Access Compliance Report

Public Rights-of-Way

(Curb Ramps)

Intersection ID: 13802	Main Street: LEXINGTON_AV	Cross Street: MYRTLE_AV	Location: W
ADA ID: 2218152DD1B0	Ramp Type: Perp	Initial Pass/Fail: Fail	Overall Compliance: No
Severity Score: 13.75			
Codes/Mitigation Info/Possible Solution		Field Measurements/Component Compliance

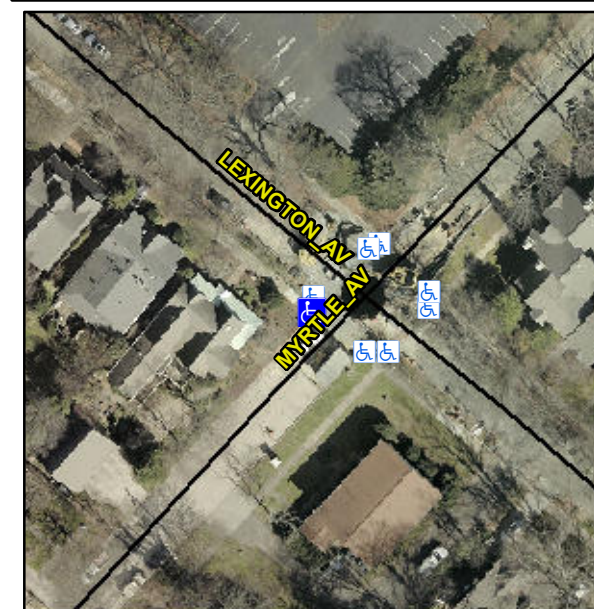
R304.2.2, R304.5.3

Compliance	Description	Data	Compliance	Description	Data
N/A	Ramp Length (in)	76.0	No	Ramp Slope (%)	10.2
Yes	Ramp Width (in)	48.0	No	Ramp XSlope (%)	2.9
N/A	Flare Type LT	N/A	N/A	Flare Type RT	N/A
N/A	Flare Slope LT (%)	N/A	N/A	Flare Slope RT (%)	N/A
N/A	Flare Traversable LT?	N/A	N/A	Flare Traversable RT?	N/A
N/A	Landing Length (in)	N/A	N/A	DWS Provided?	N/A
N/A	Landing Width (in)	N/A	N/A	DWS Contrast?	N/A
N/A	Landing Slope (%)	N/A	N/A	DWS Length (in)	N/A
N/A	Landing X Slope (%)	N/A	N/A	DWS Full Width?	N/A
N/A	Landing Curb? (Y/N)	N/A	N/A	DWS Offset (in)	N/A
N/A	Shared Landing?	N/A			
N/A	Gutter Ponding?	N/A	N/A	Gutter Slope (%)	N/A
N/A	Gutter Lip Ht (in)	N/A	N/A	Gutter X Slope (%)	N/A
N/A	Painted X Walk1?	No	N/A	Painted X Walk2?	N/A
	X Walk 1 Direction	To SE		X Walk 2 Direction	N/A
N/A	X Walk 1 Width (in)	N/A	N/A	X Walk 2 Width (in)	N/A
	X Walk 1 Slope (%)	0.9		X Walk 2 Slope (%)	N/A
	X Walk 1 X Slope (%)	3.2		X Walk 2 X Slope (%)	N/A

Remove & Replace Entire Ramp.
